DEPARTMENT OF BIODIVERSITY, CONSERVATION AND ATTRACTIONS REPORT

PROPOSAL	Redevelopment of Pier 21 Marina – removal of seven jetties and replacement with six new floating jetties with wave attenuation, public boardwalk and community use jetty
LOCATION	River reserve – Lot 300 on Plan 47450 (Reserve 48325) and Regional Open Space – Lots 505 and 506 on Plan 54517 (Reserve 49288) and Lot 431 on Plan 215710 (Reserve 43707)
COST	\$10,000,000
APPLICANT	Pier 21 Marina Pty Ltd
LANDOWNER	Swan River Trust and City of Fremantle
LOCAL GOVERNMENT	City of Fremantle
MRS CLASSIFICATION	Waterways; Regional Open Space
DECISION TYPE	Part 5, <i>Swan and Canning Rivers Management Act 2006</i> , Ministerial Determination
ATTACHMENTS	1. Location Map (one page) 2. Amended Development Proposal: a) Amended plans and application (18 pages) b) Wake Wave Reflection Report (13 pages) c) Visual Impact Assessment (71 pages) d) Car Parking Analysis (nine pages) e) Parking Report by Transcore (22 pages) f) Parking Assessment (44 pages) 3. Initial Development Proposal (19 pages) 4. External referral responses: a) City of Fremantle (11 pages) b) Department of Water and Environmental Regulation – Contaminated Sites Bra

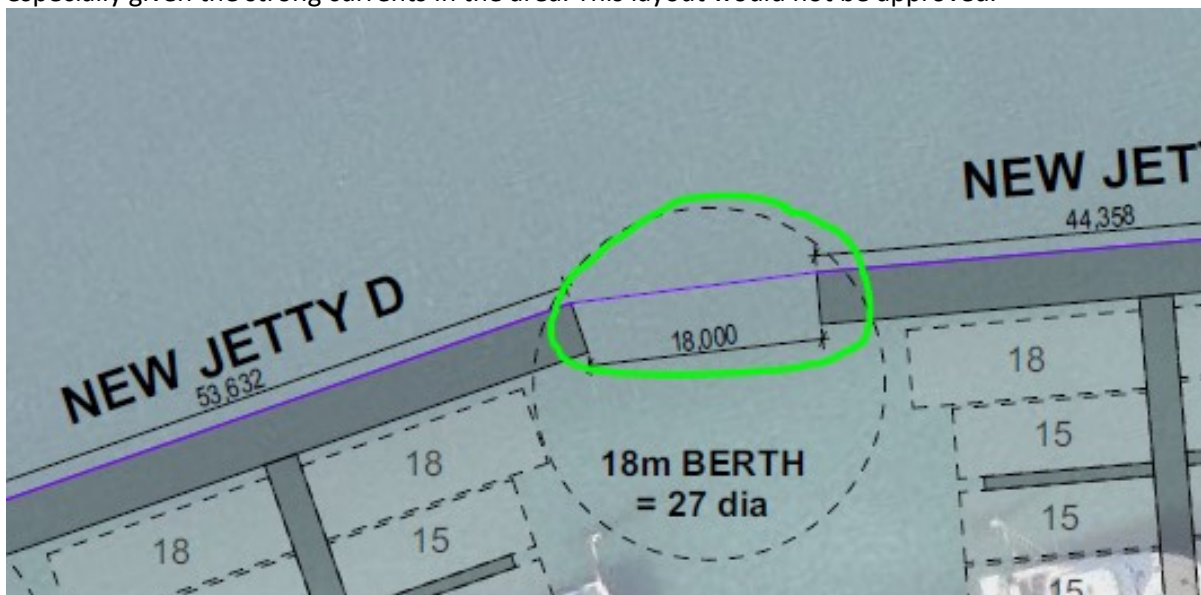
Mooring Piles: Mooring piles are not shown between berths. These should be considered, particularly for the larger pens.

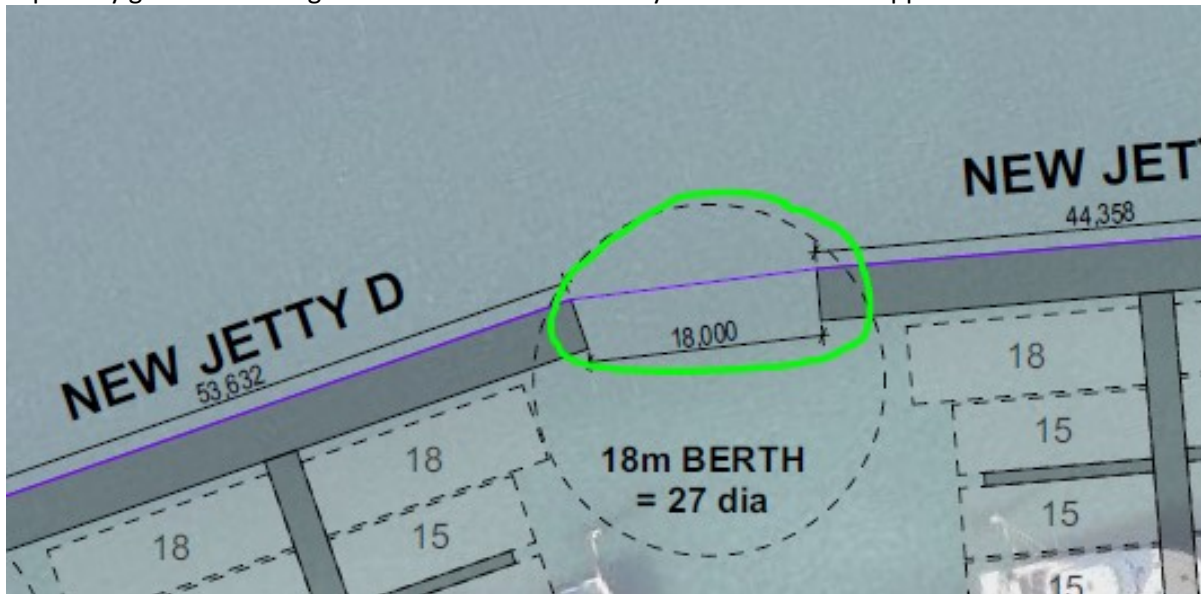
Fairways / Internal Channels: The fairways and internal channels appear to meet the minimum requirements of AS3962 (1.5L). However, the pinch point at the T-Head of each fairway / channel does not meet this minimum requirement. This pinch point, being only 18m wide, could pose a safety concern for vessels entering and exiting the pen system, especially given the strong currents in the area. This layout would not be approved.

Mooring Piles: Mooring piles are not shown between berths. These should be considered, particularly for the larger pens.

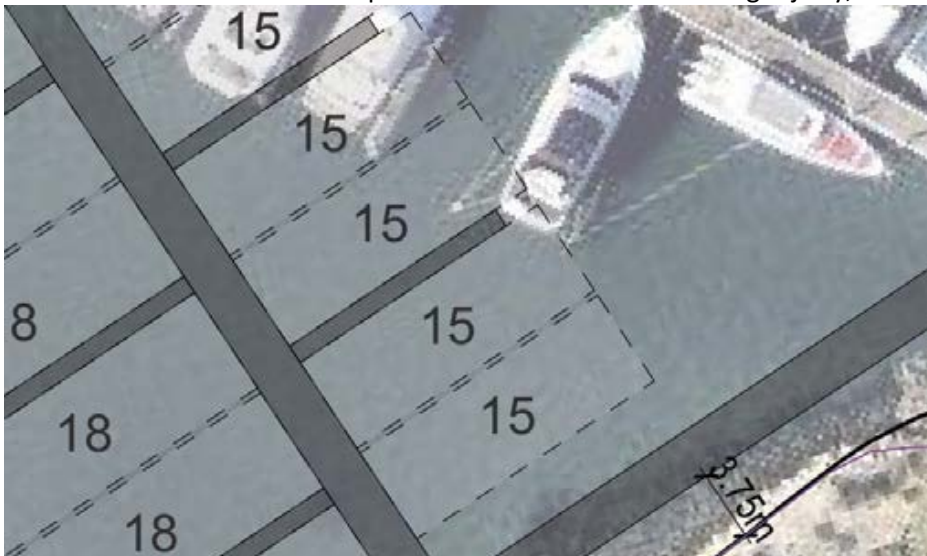
Inner Pens: Some of the inner pens do not have access to a finger jetty, as illustrated below.

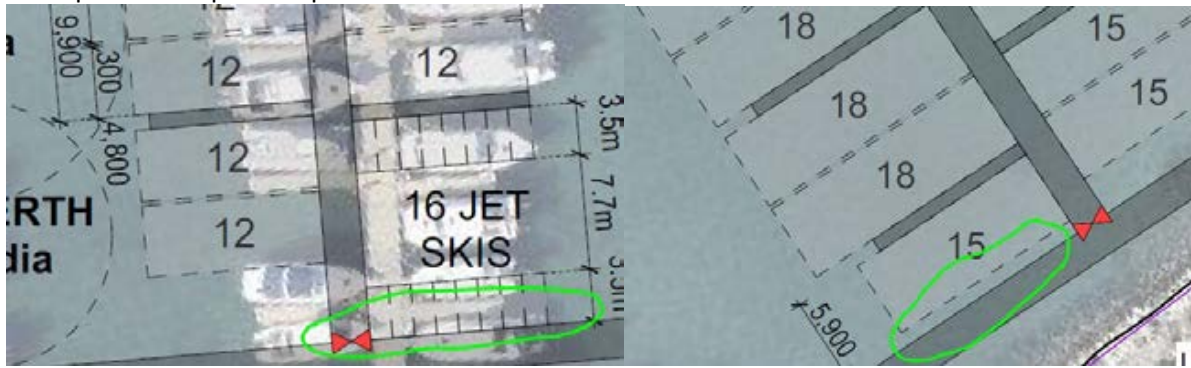
Security: There are potential security concerns with people on the public boardwalk being able to access some of the inner pens. Examples are provided below.
